Subject: Interstate 95 & Broadway Bridge
replacement, with Intersection safety

State WIN: 021663.00 & 022276.01

Amendment No. 3

SIGNAL NOTES

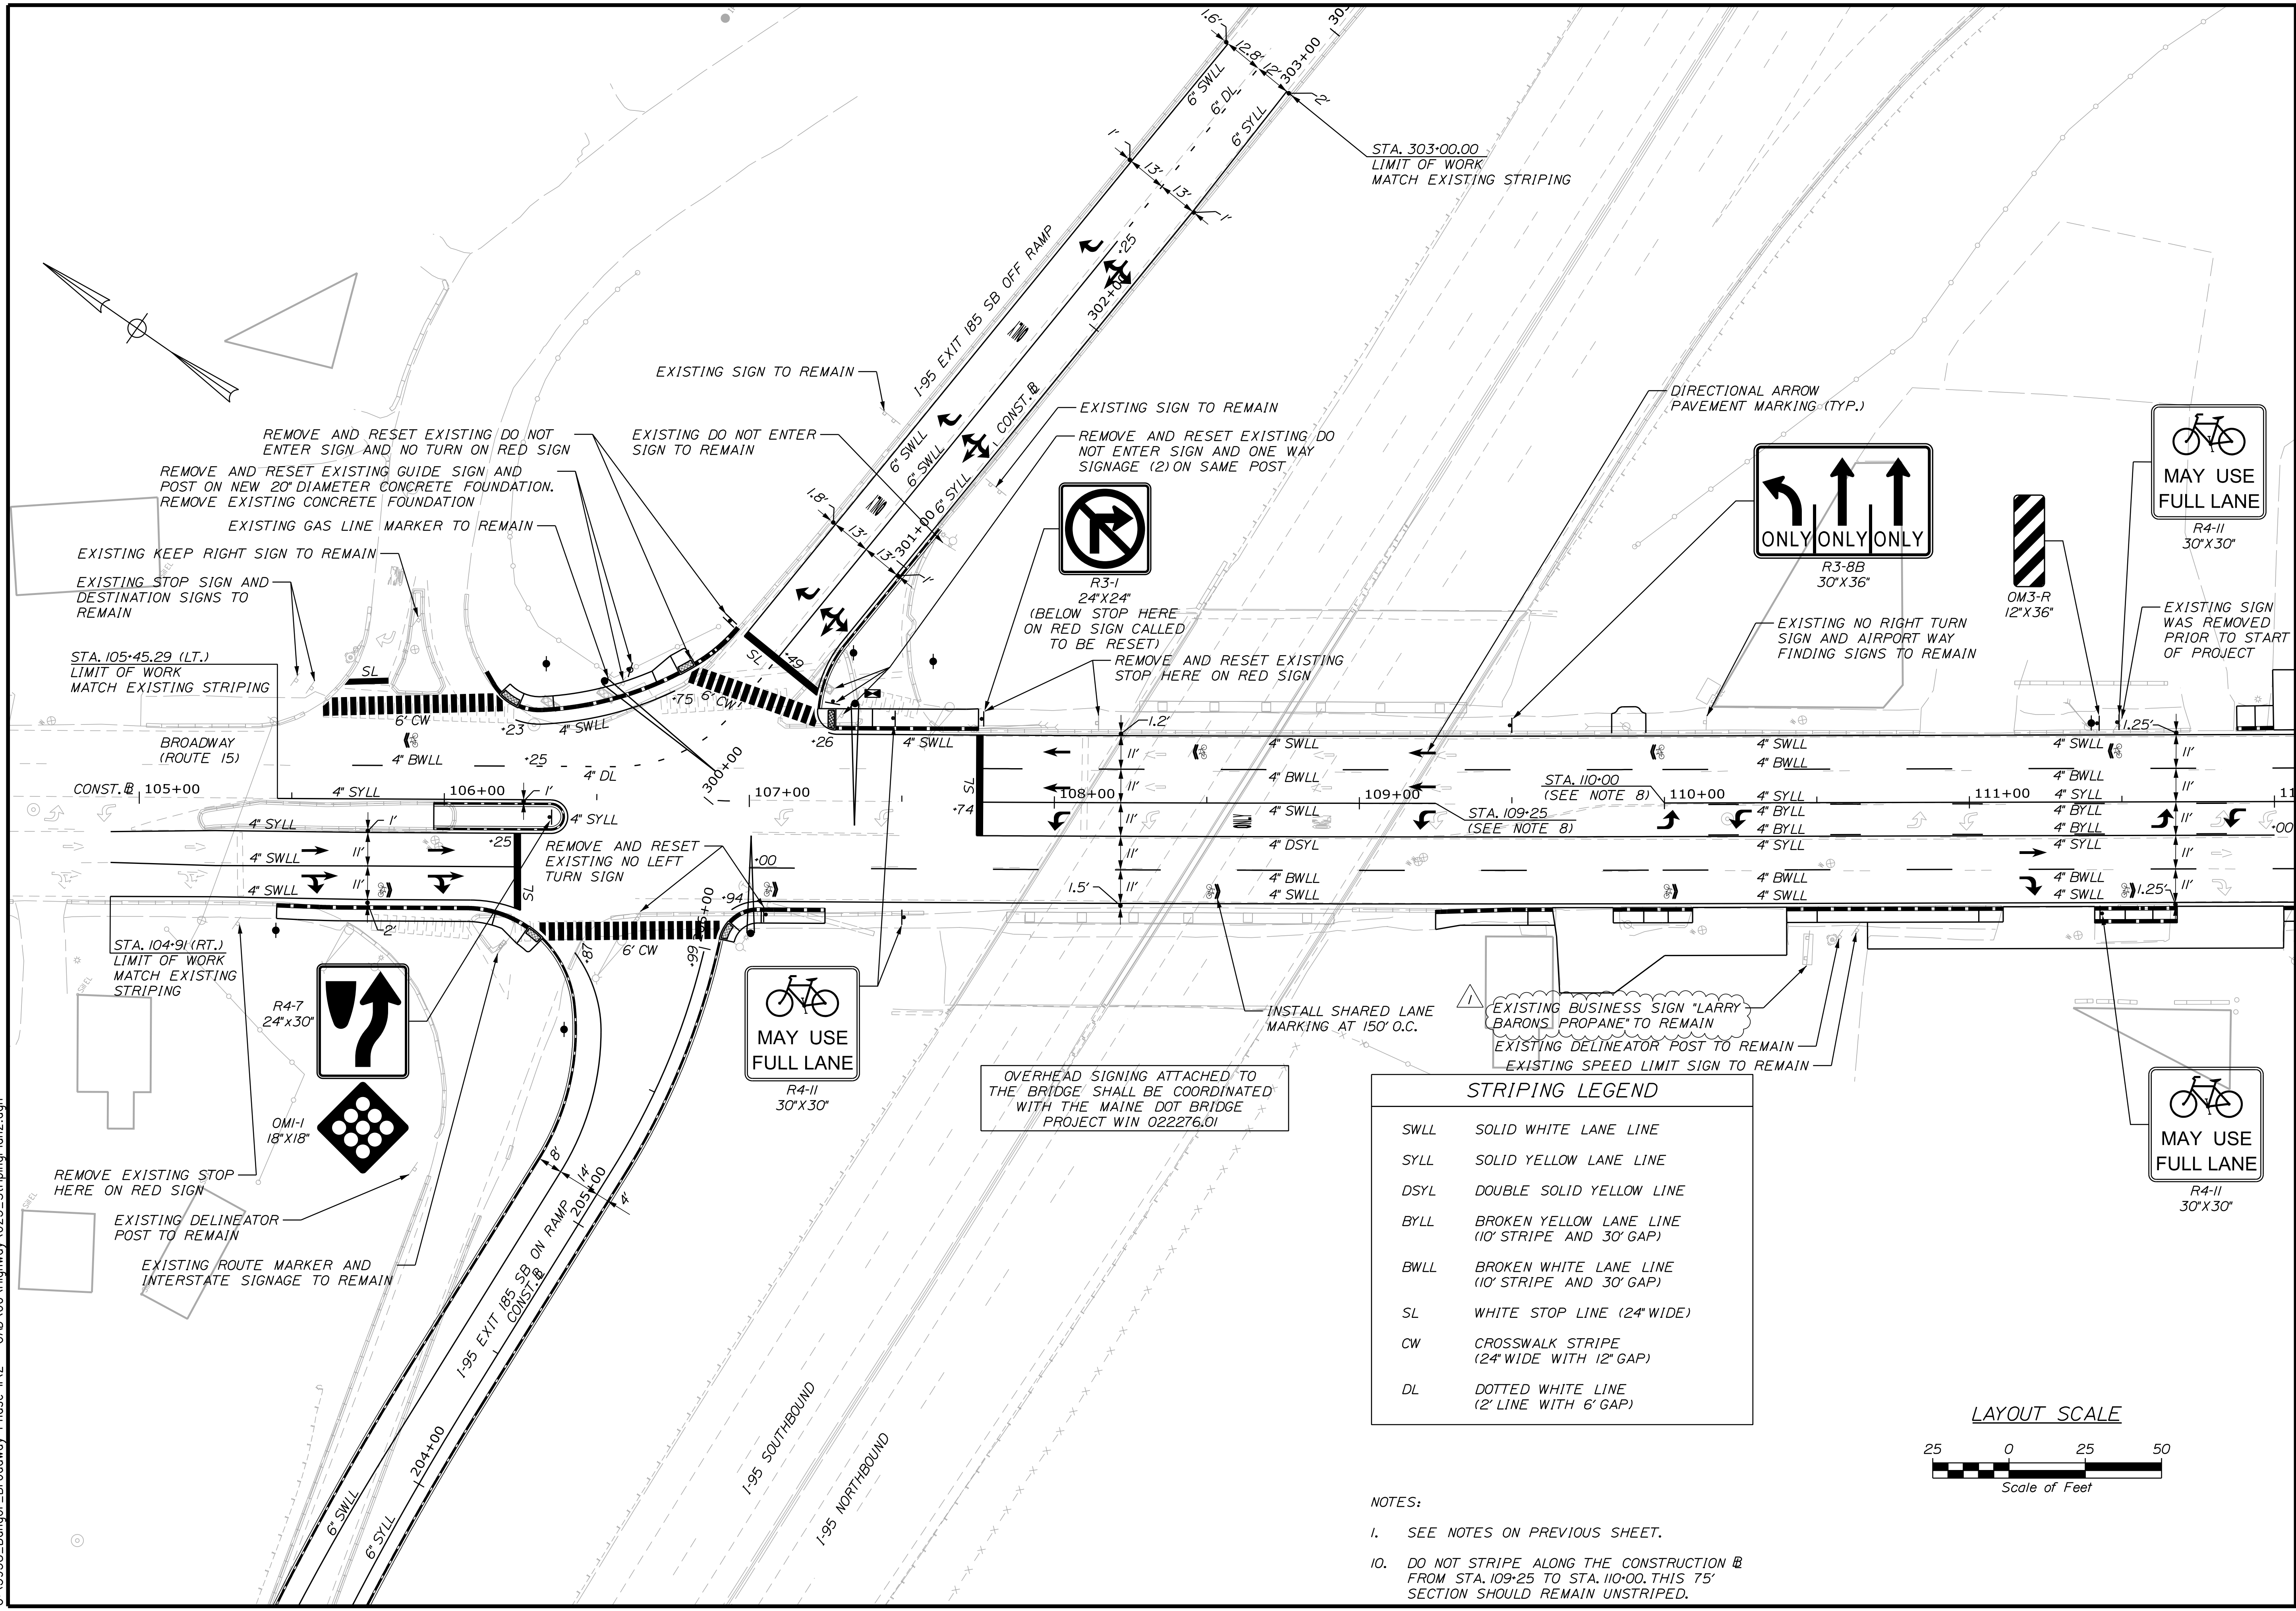
Question: In the project signal notes on page 20, note 29 states the video detection shall be FLIR Trafisense 2. Note 36 states the video detection shall be Traficam X-Stream. Note 48 states the video detection shall be Gridsmart, Miovision, Flir or Wavetronix. Please clarify which is correct.

Question: On Sheet 20 of 59, Signal Notes:

Note #29 calls for FLIR TRAFISENSE2 (Termo based system) for video detection.

Note #36 calls for video detection to be Trafficom X-Strem video.

Note #48 calls for stop bar detection to be supplied by Girdsmart, Miovision, Flir or Wavetronix.

Note #49 requires Wavetronix smart sensor advance for advanced vehicle detection.

Please clarify which detection system/manufacturer is required for this project.

Question: On Sheet 20 of 59, Signal Notes:

Note #55 requires the Polara iN3 Navigator-3 pedestrian signal system. Will approved equals be accepted?

Response: Stop bar video detection shall be supplied by one of the following manufacturers:

- Mio Vision
- Flir (thermal)

Response: Stop bar video detection shall be supplied by one of the following manufacturers:

- Mio Vision
- Flir (thermal)

Response: Approved equals will be considered by the City of Bangor; however, the preference is to match the manufacturers currently used within the city.
